## A. Meeting Summary:

### Proposed Scope of Work:

- 1) Proposed development: A design review for a structural addition of more than 25% to an existing building
- 2) Site Coverage: 24,284sqft
  - a) Building:

Figure 1: Ada County Assessor's Parcels Owned By Western Heating and Air

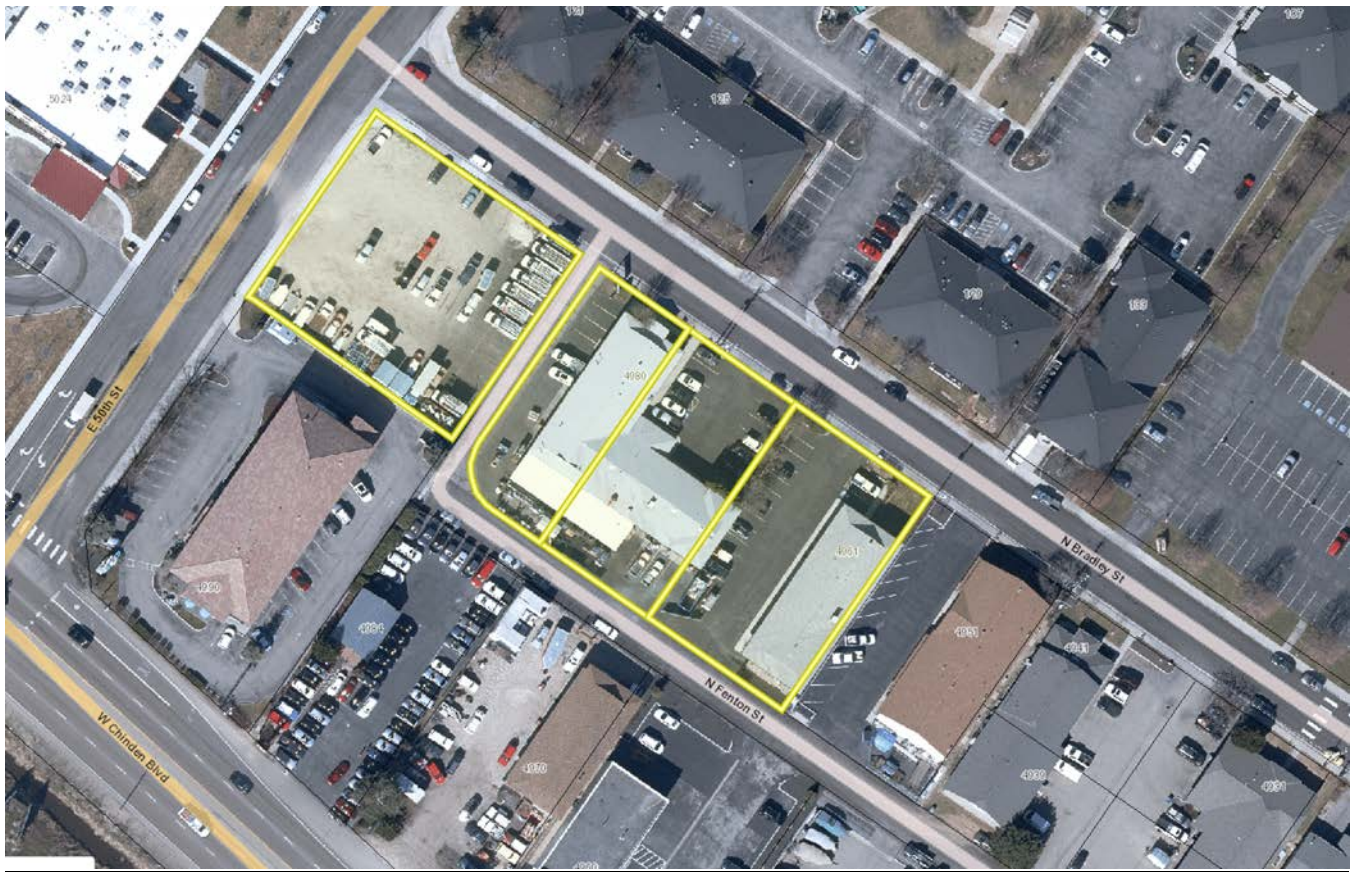
As there are a number of adjacent properties that Western Heating and Air is utilizing as a single business, staff suggests that it is reasonable to review the properties that constitute the site as a part of this review. ([Figure One](#))

<b>Garden City Title 8 Code Sections</b>			
Code Section	Review Authority	Compliance Issues	Analysis/ Discussion
<b>Title 8, Chapter 1: General Regulations</b>			
<a href="#">8-1A-4 Applicability</a>			The regulations of Garden City Code, Title 8 Development Code of the City, shall apply and govern development and use of all properties within the corporate limits of the city.
<a href="#">8-1B-1 Nonconforming Properties</a>		No compliance issues noted	The site consists of lots 6, 7, and 8 of Bradley Field Business Park Subdivision. All of which appear to be described as legal lots of record.
<a href="#">8-1B-2 Nonconforming Structures</a>		May not be complaint – Compliant as conditioned	It appears that the site consists of three lots of record. The existing structure and the proposed expansion are and will be crossing all three lot lines. A lot line adjustment shall be required and has been made a drafted condition for approval.  There was a Record of Survey submitted with this application, dated 09-02-2020, however there is not a City Engineer Signature on the ROS to determine that it was legally recorded with the City. Ada County Assessors website shows that the eastern most property boundary line to run through a section of the building, causing the building encroachment into Lot 6. <a href="#">(Figure One)</a>
